Rezoning Transportation Analysis

Petition Number: 2020-111

General Location Identifier: 14117104.

| Date | Description |
|------------|--------------------|
| 09-10-20 | First Review (KP) |

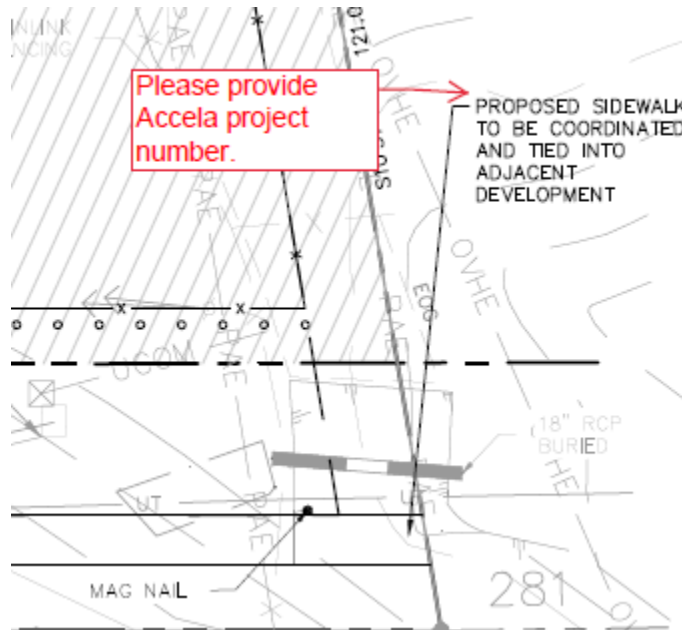
3. ~~Commit to dedicate 52 feet of right of way from the Dixie River Road centerline, labeled and dimensioned from the road centerline, on the site plan and conditional note(s).~~

4. Commit to construct an 8-foot planting strip, and 6-foot sidewalk on Dixie River Road and connect to the sidewalk constructed as a part of the Berewick Senior Apartments development, as required by City Ordinance. This should be shown on the site plan, labeled and dimensioned from the back of curb and gutter, as well as noted in the conditional notes.
